## Product Change Notice (PCN)

**PCN Number:** PCN-0450216R-01

**Product(s) Affected:** MD-SV series (part numbers MD-30SV, MD-40SV, MD-50SV, MD-60SV, MD-70SV, MD-80SV).

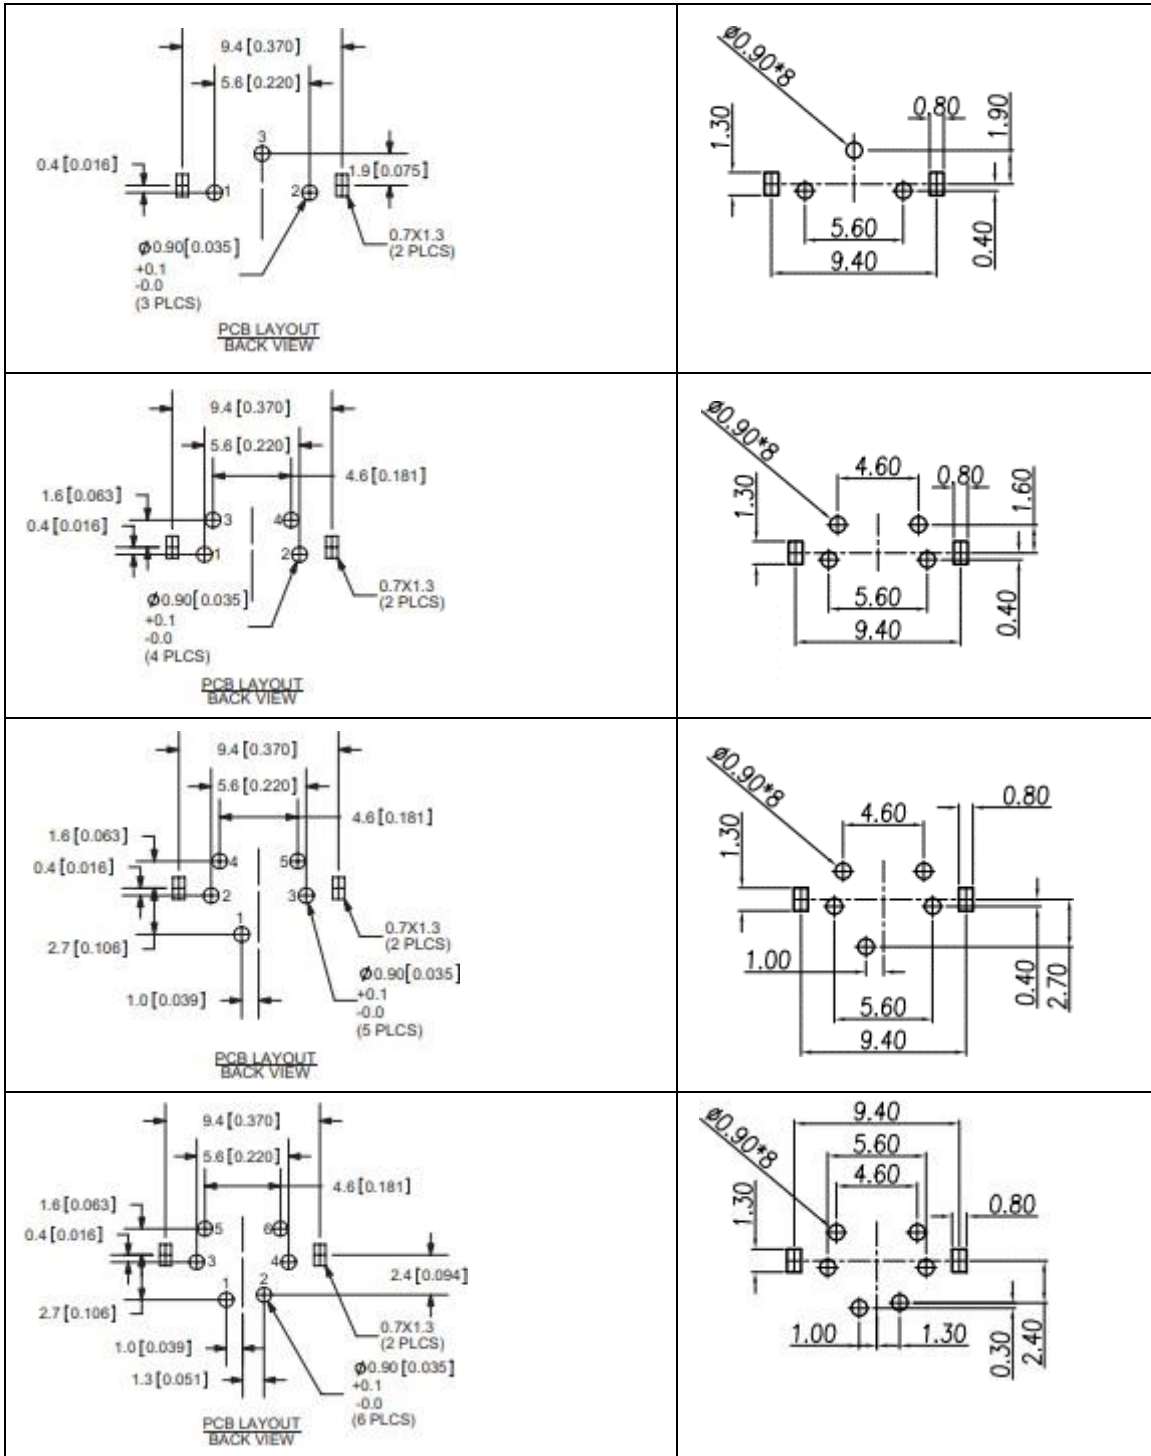
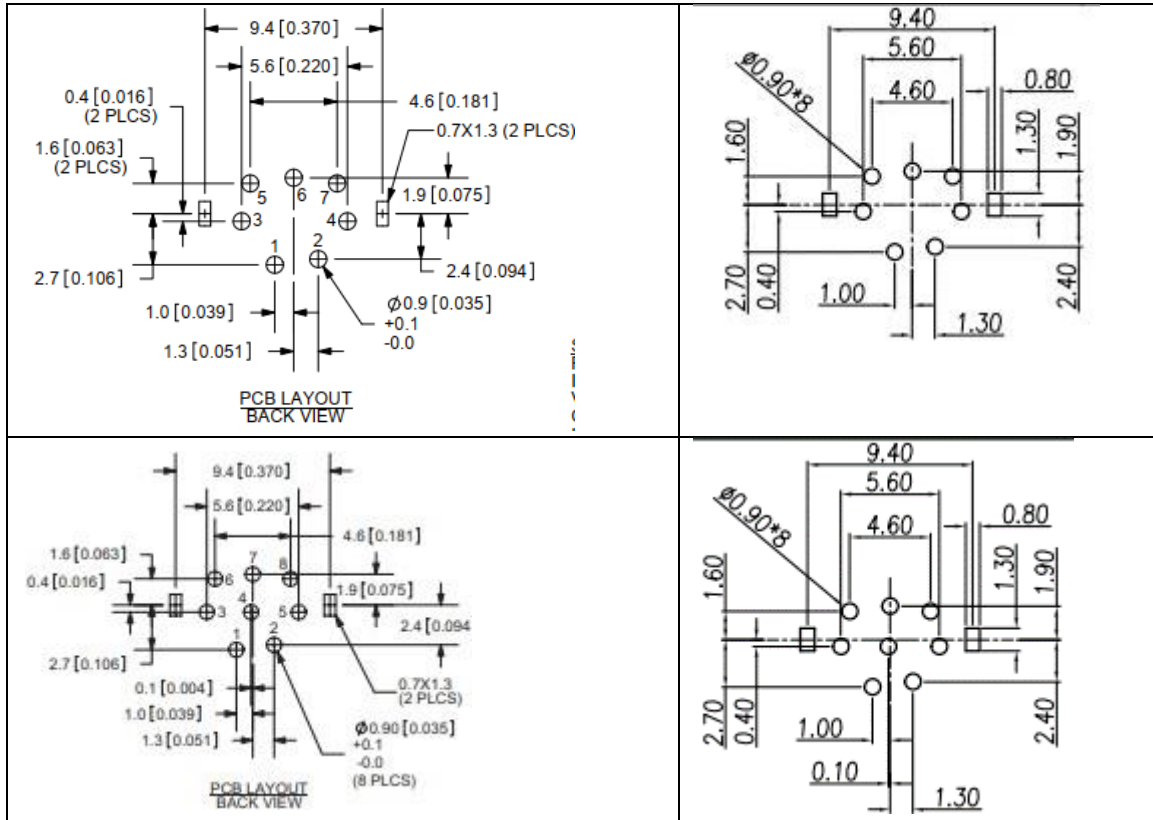
**Description of Change:** minor dimensional changes, such as pin length, and materials changes as shown below.

### Old design materials

MATERIAL	PLATING
earth terminal	brass	tin
contact terminals (1~8)	phosphor bronze	silver
plastic	PBT

### New design materials

MATERIAL	PLATING/COLOR
housing	PBT (UL94V-0)	black
contacts	phosphor bronze	tin
shell	brass	nickel
